Client  
Tenterden Town Council  
24 High Street  
Tenterden  
Kent TN30 6AN

Project  
Proposed Extension to Existing Toilet Block to Provide New Maintenance Building  
St Michaels Recreation Ground, Tenterden

Drawing Name  
Proposed Layout Plans

Drawing No  
003

Layout Plan  
scale 1:50 @ A1

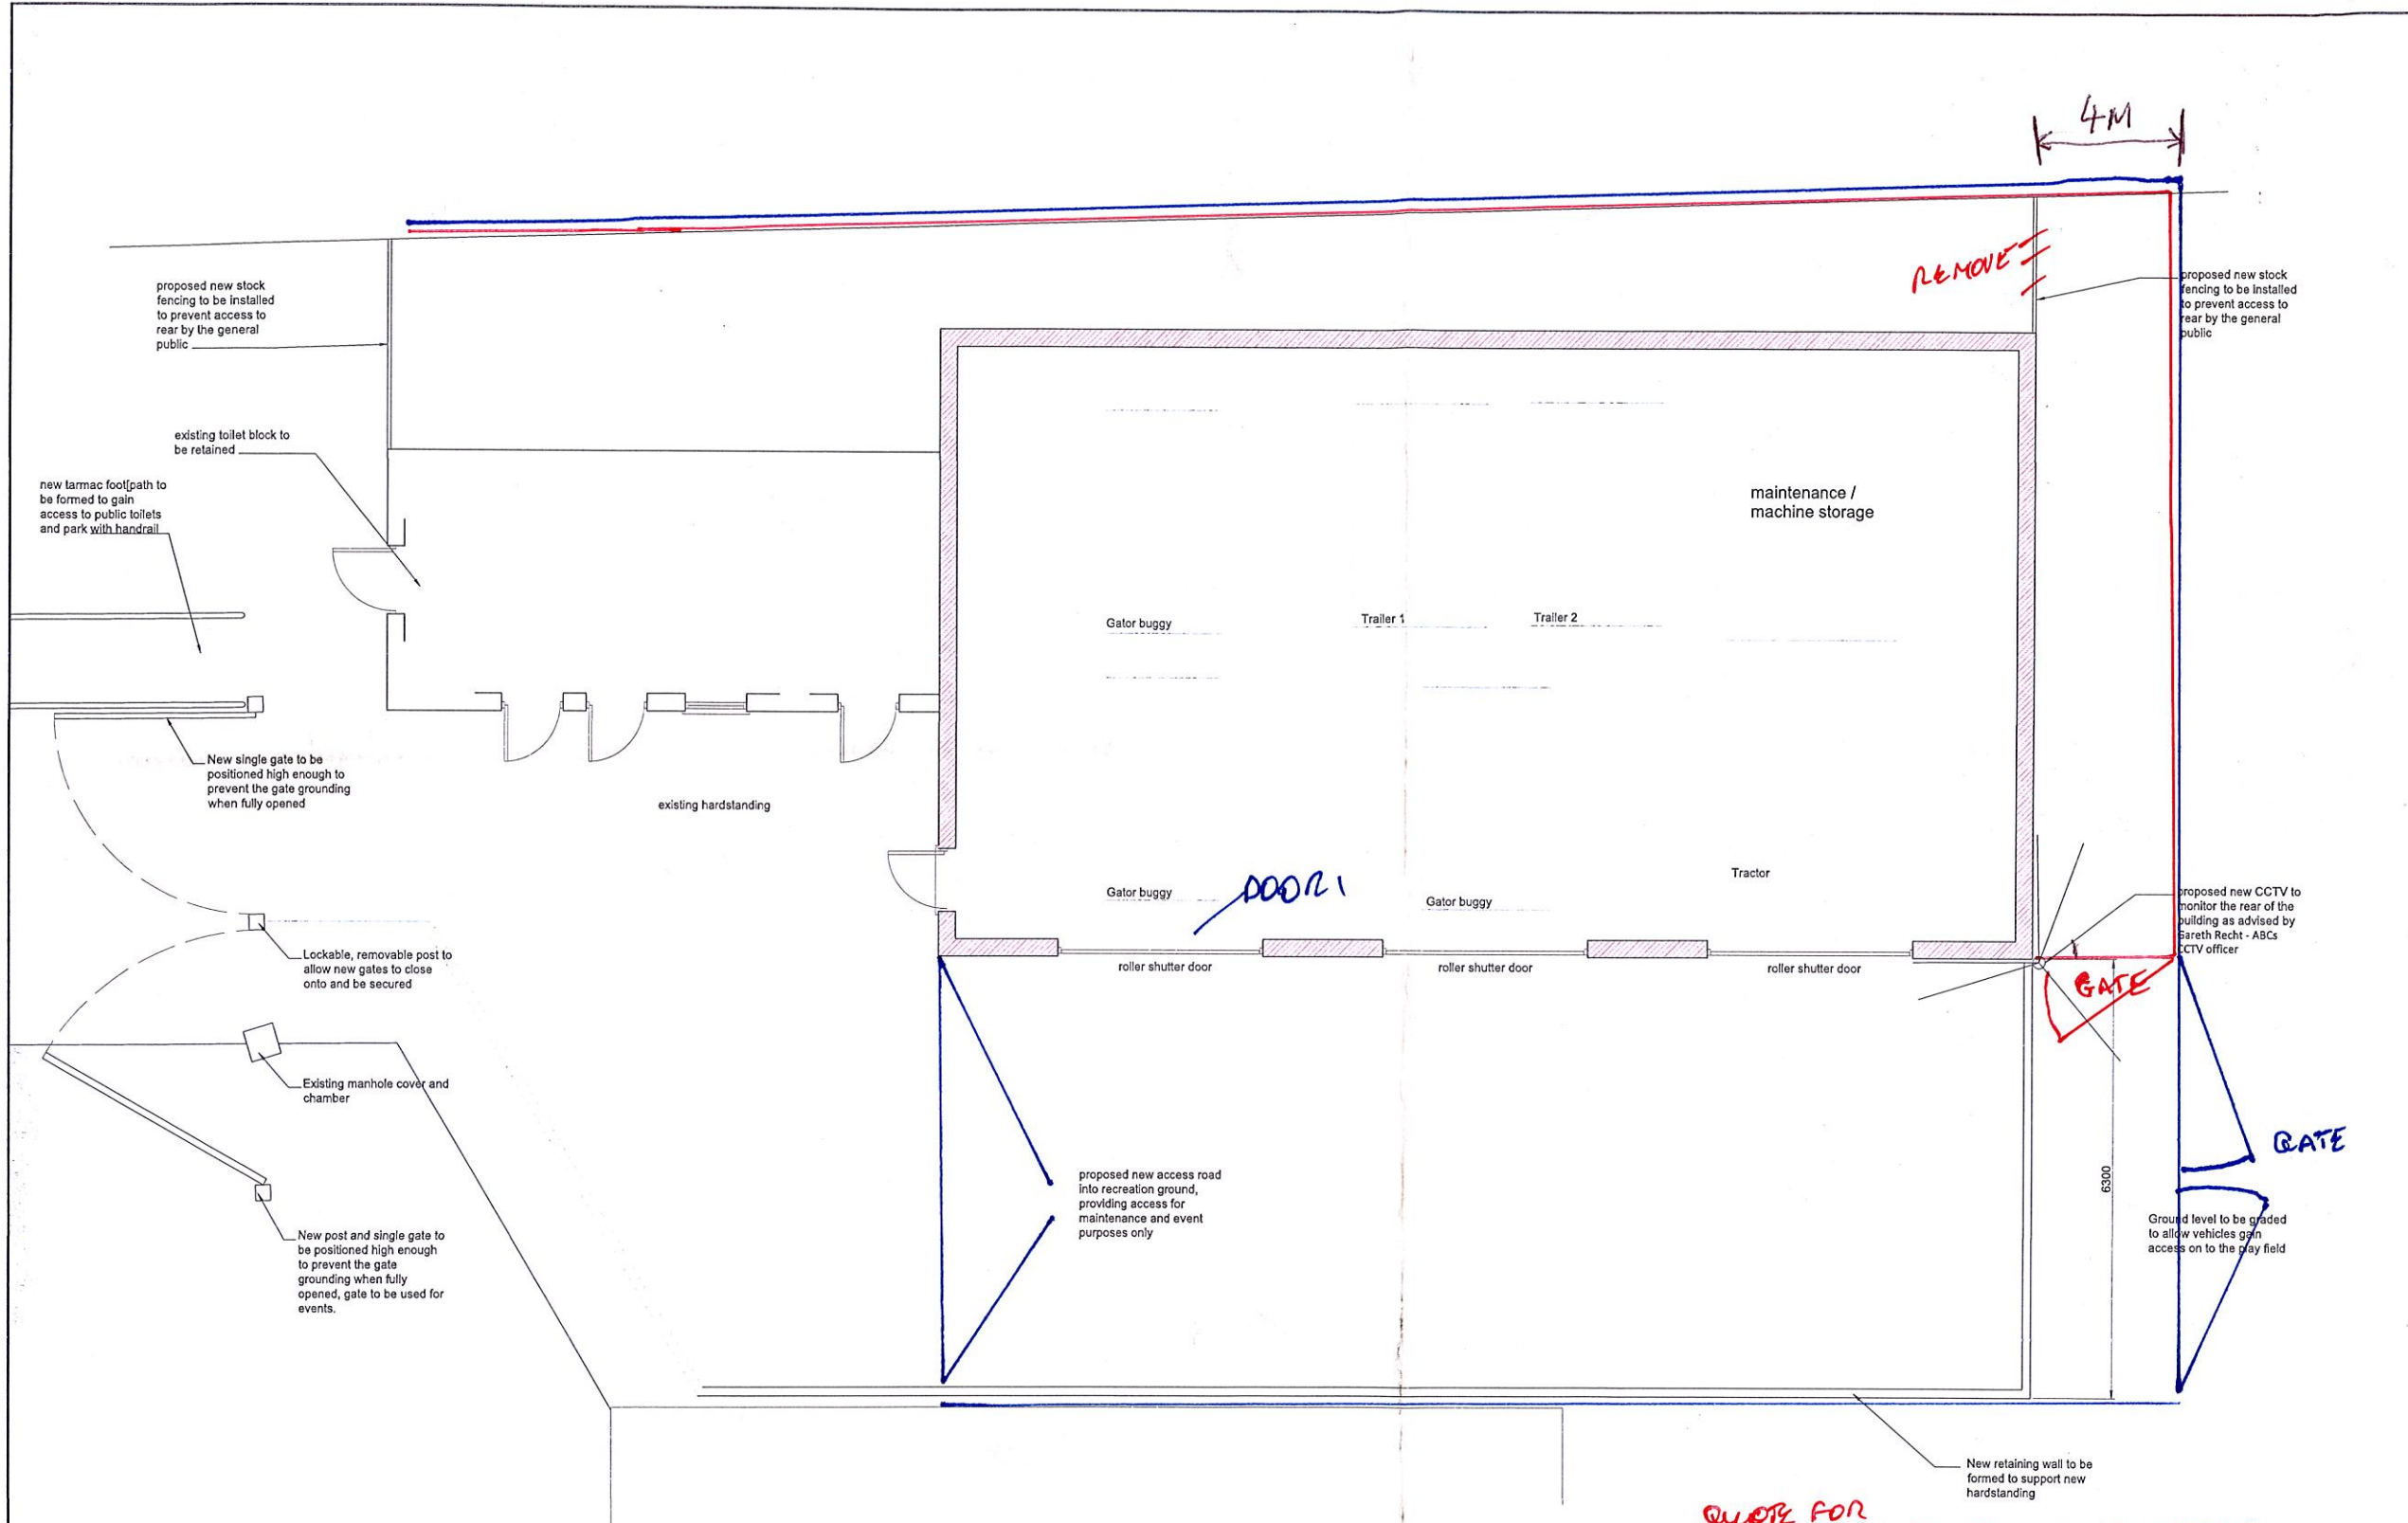
**QUOTE FOR OPTION 1 - PLEASE ADD FENCE TO SOUTH ELEVATION £2295 QUOTED FOR WEST ELEVATION**

**OPTION 2 FULL PERIMETER FENCE. NORTH ELEVATION OUTSIDE NEW WALL. L/H ENTRANCE GATE IMPEDES DOOR 1 BUT WOULD ONLY BE USED FOR EVENTS QUOTE PLEASE**
